CLEVELAND NATIONAL FOREST POWER LINE REPLACEMENT PROJECTS

MINOR PROJECT REFINEMENT REQUEST FORM

Date Submitted:	03-06-20	Request #:	46
Date Approval Required:	03-20-20	Landowner:	Tulloch Family Partners LP
APN:	412-060-01, 412-020-02, and 412-010-02		
Refinement from (check all that apply):			
<input type="checkbox"/> Mitigation Measure	<input type="checkbox"/> APM	<input checked="" type="checkbox"/> Project Description	<input type="checkbox"/> Drawing <input checked="" type="checkbox"/> Other
Identify source (mitigation measure, project description, etc.):			
<p>Notice to Proceed (NTP) request #23 for Phase I Overhead of Circuit (C) 440 of the Cleveland National Forest Power Line Replacement Projects (Project) was approved by the United States Forest Service (USFS) on June 28, 2019 and by the California Public Utilities Commission (CPUC) on July 11, 2019. Since this approval, San Diego Gas & Electric Company (SDG&E) has identified additional anchors needed to reduce blowout (i.e., horizontal movement of conductors) and access road modifications along Phase I Overhead of C440. A brief description and justification of the refinements are provided on page 2 of this MPR request.</p>

**Attachment B:
Comparison Map
Phase I Overhead of C440 Map 5 of 7**

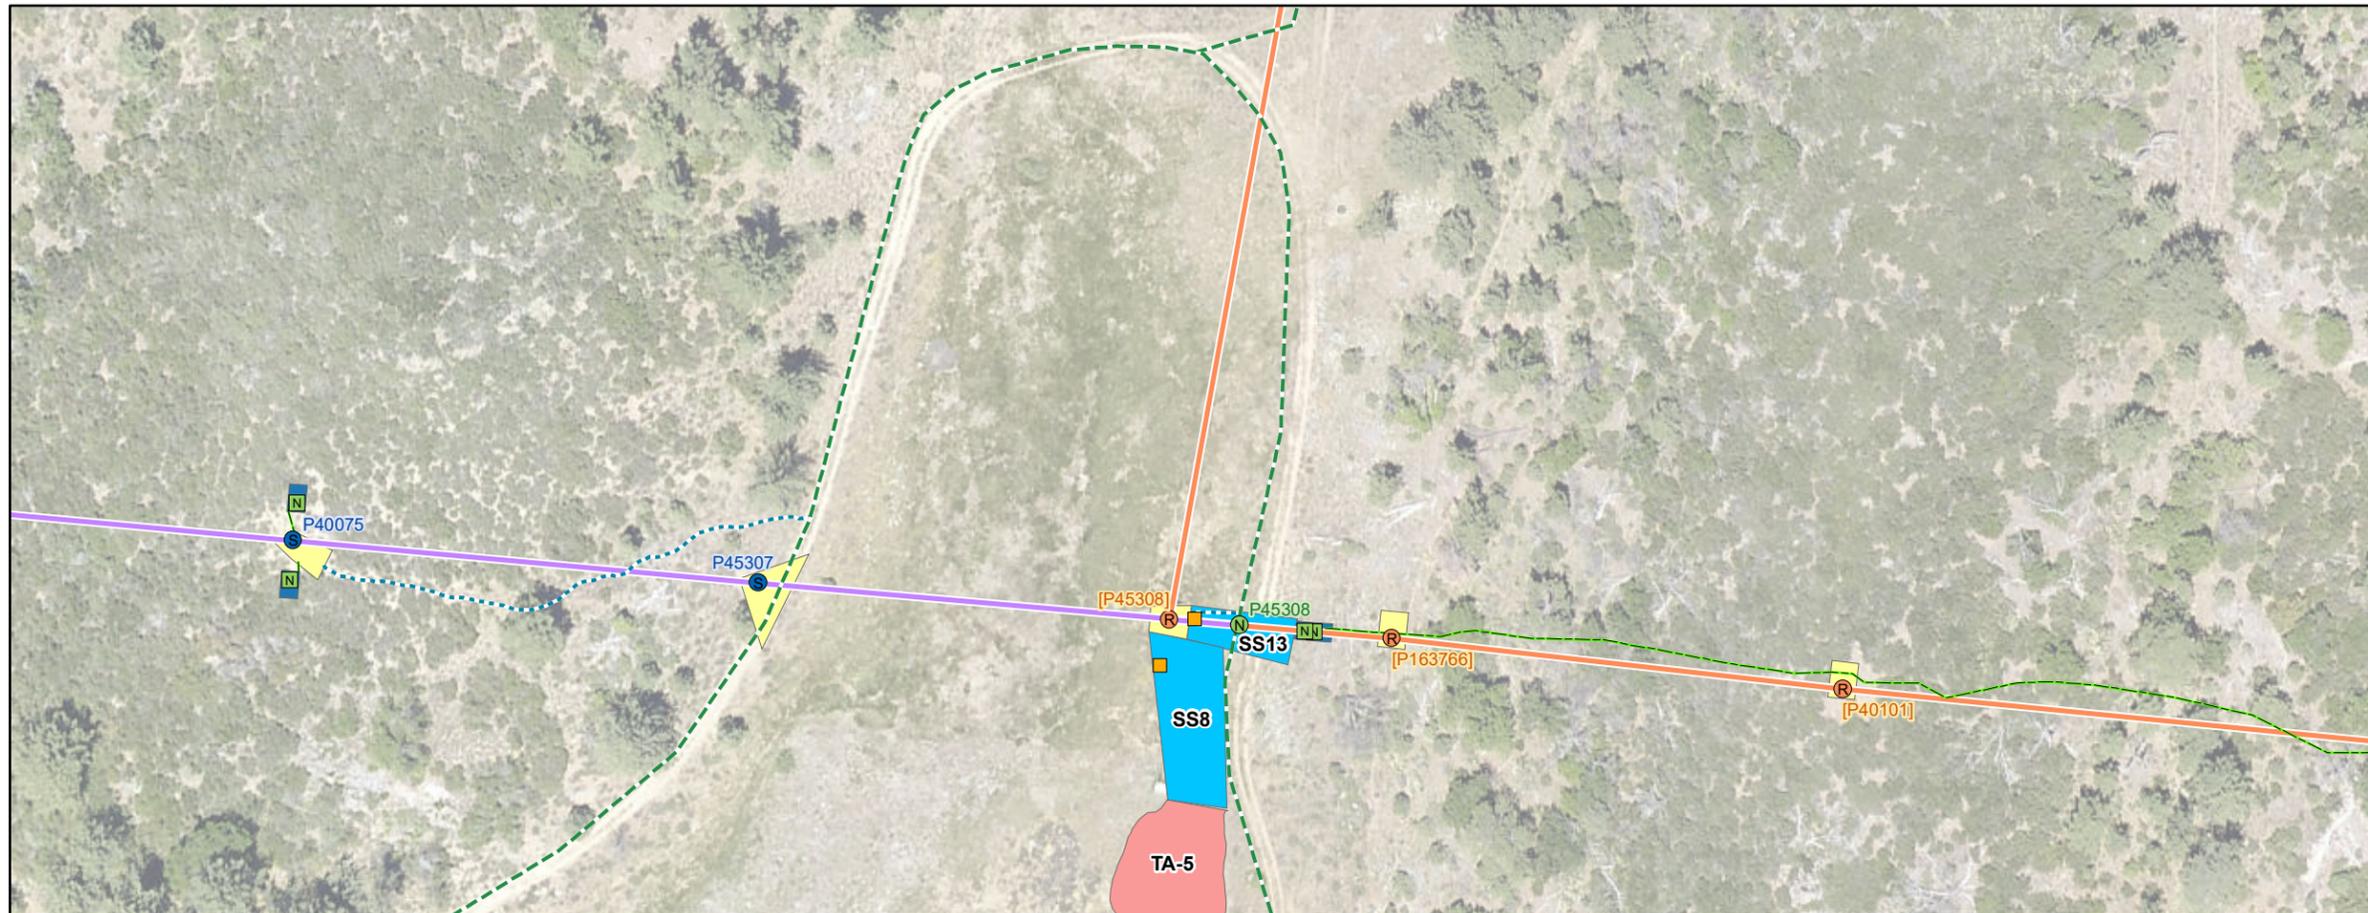
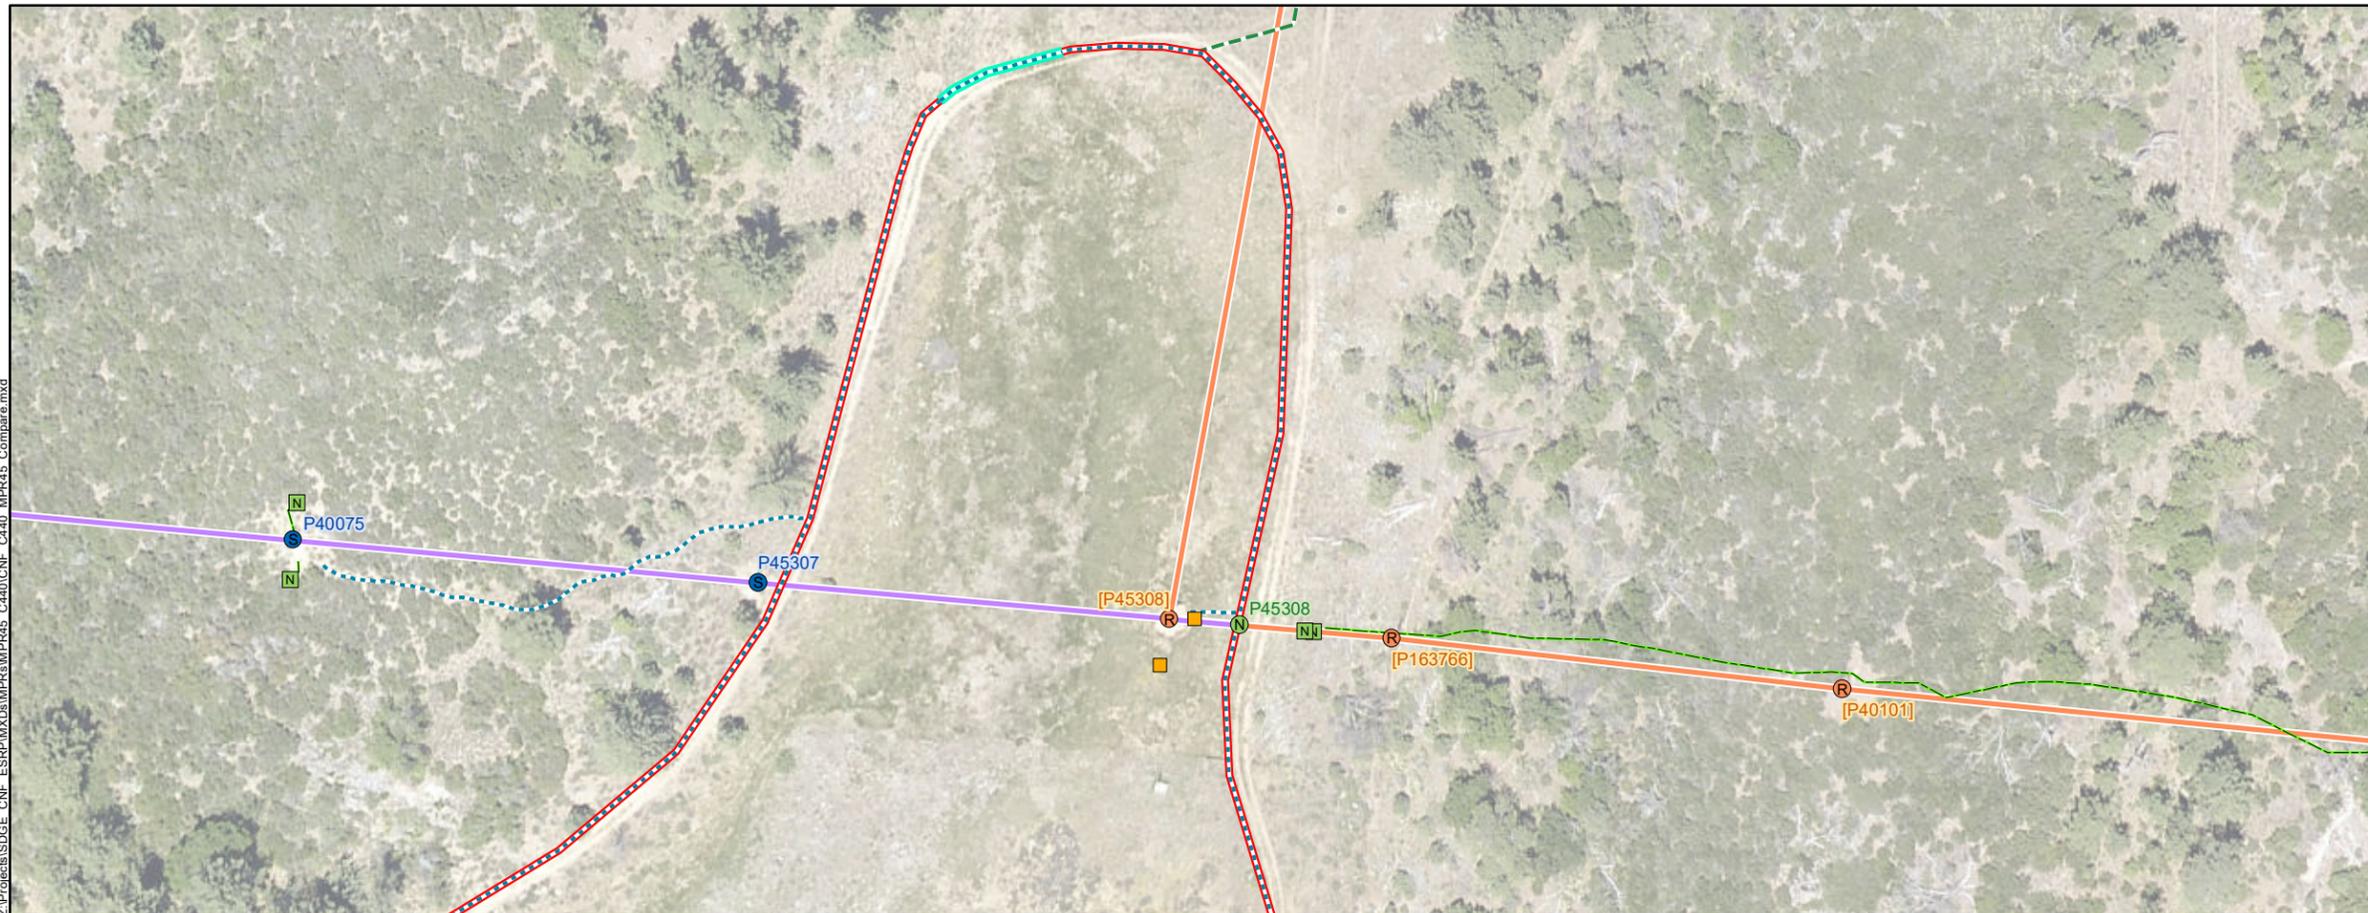
- Construction-Only Access Road (No Grading)
- Construction-Only Access Road
